SAFETY EVALUATION BY THE OFFICE OF NUCLEAR REACTOR REGULATION

RELATED TO AMENDMENT NO. 140 TO

FACILITY OPERATING LICENSE NO. DPR-51

ARKANSAS NUCLEAR ONE, UNIT NO. 1

**FIGURE 2
PLANNED MODIFICATION**

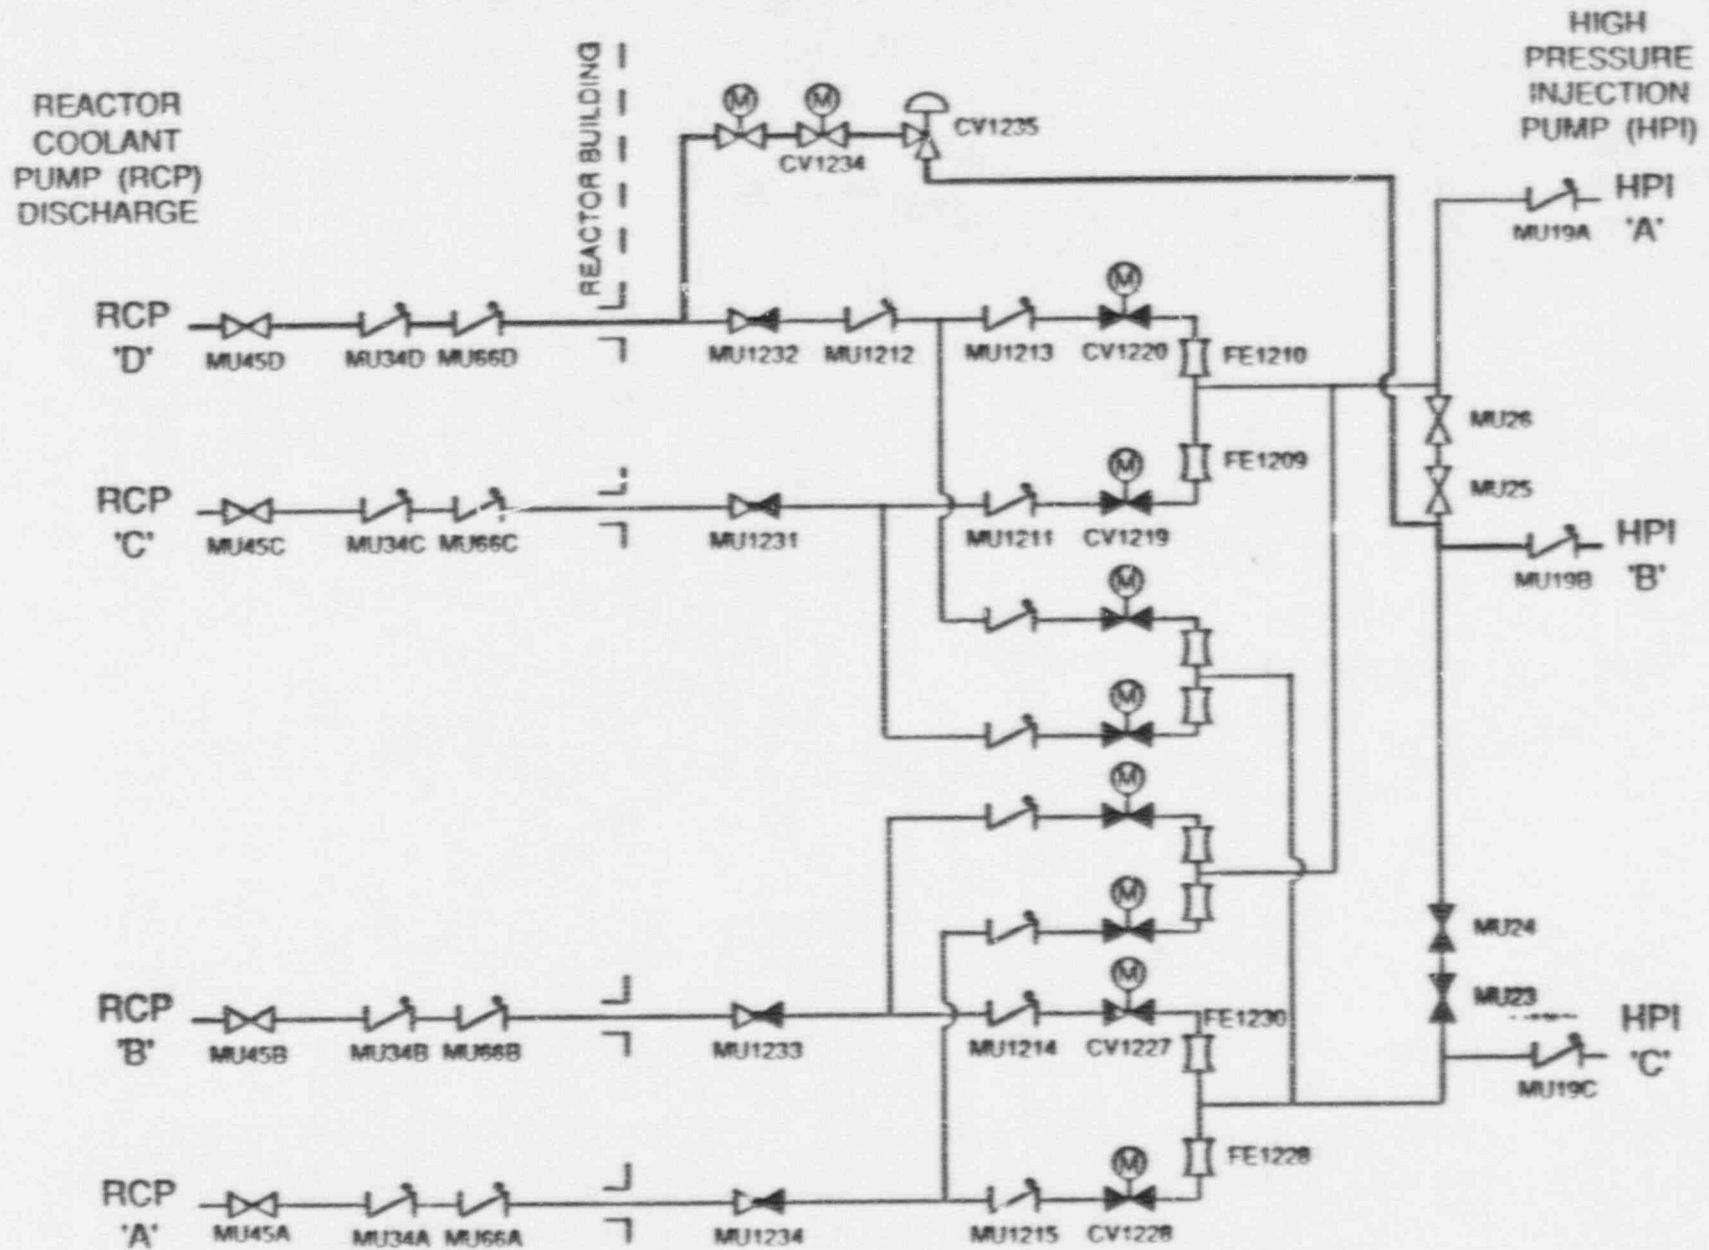
The specific small break LOCA addressed with the HPI system piping modifications analysis and testing is the HPI line break, between the RCS connection and the first HPI line check valve. The proposed arrangement is shown in Figure 2 and includes four additional injection lines with throttling isolation valves and flow instrumentation (flow indicators) powered by the same train of safety grade power as the pump which supplies them. With this modification each injection pump will be able to supply borated water through four lines with individual flow indication and throttling isolation valves. Given any

single failure, this arrangement allows a broken line to be throttled independently to enable the intact lines to provide adequate HPI flow. This arrangement will incorporate twice as many flow lines as previously with an equal number of flow meters equipped with safety grade chart recorders (Regulatory Guide 1.97, Type A, Category 1). Manual globe valves in the new lines will be pre-throttled to provide a balanced system flow.

- EOP guidance will direct the operator to throttle the high injection flow line to within 20 gpm from the next highest flow injection line
- Each line will be provided with high point vents and low point drain
- Post installation testing will confirm the pre-throttled flow
- The new valves will be tested to ASME Section XI
- The pumps will continue to be tested for degradation to ASME Section XI

The staff concludes that the proposed HPI arrangement provides adequate flow for the limiting HPI line break and meets existing requirements for steam line break and generator tube rupture. Therefore, the staff finds it acceptable subject to confirmation of its performance with post implementation testing.
